Model: Model PL-P1		Date: 30-Apr-04	No.: MG108001
Modified Article: Parts Catalog Correction		Prepared by: H.Taguchi	
From: 1st Tech. Support Sec. Service Support Dept.			
Reason for Modification:	<input checked="" type="checkbox"/> Parts catalog correction	<input type="checkbox"/> Vendor change	<input type="checkbox"/> To meet standards ()
	<input type="checkbox"/> To facilitate assembly	<input type="checkbox"/> To improve reliability	
	<input type="checkbox"/> Part standardization	<input type="checkbox"/> Other

Please apply the following correction to your Parts Catalogs:

Page 4: Index 2 has been revised.

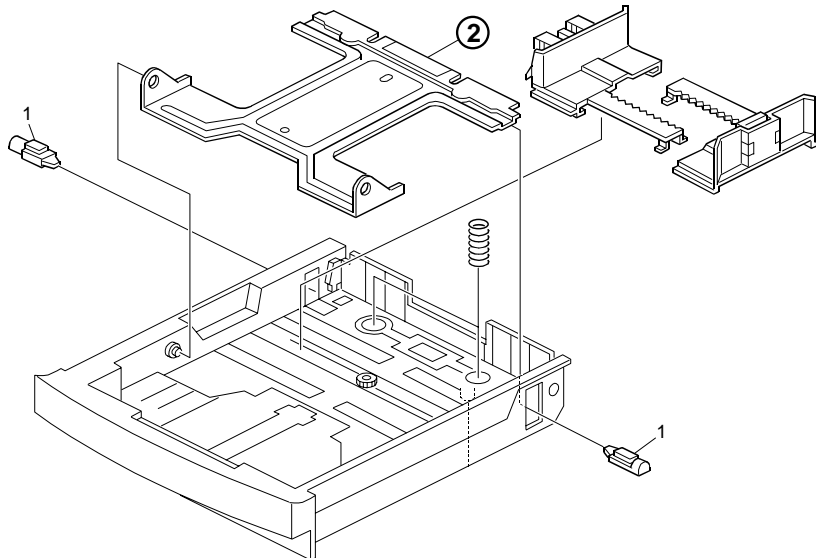
The illustration has been changed as follows.

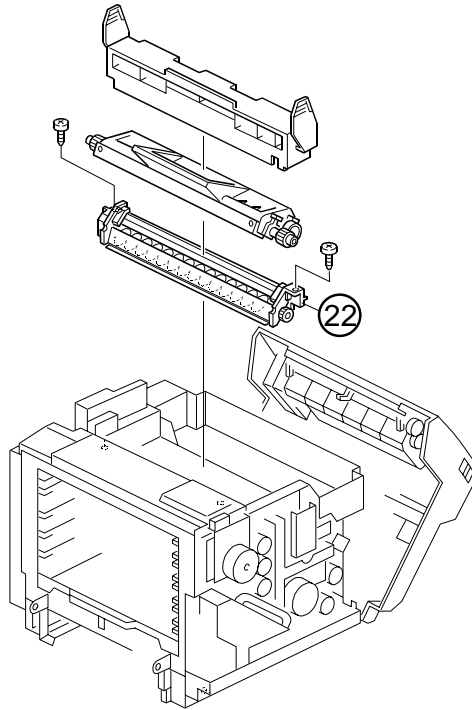
The following has been newly registered as a service part to further facilitate servicing in the field.

Old part number	New part number	Description	Q'ty	Int	Page	Index	Note
	V128444	Waste Toner Auger PU	1		3	22	NEW
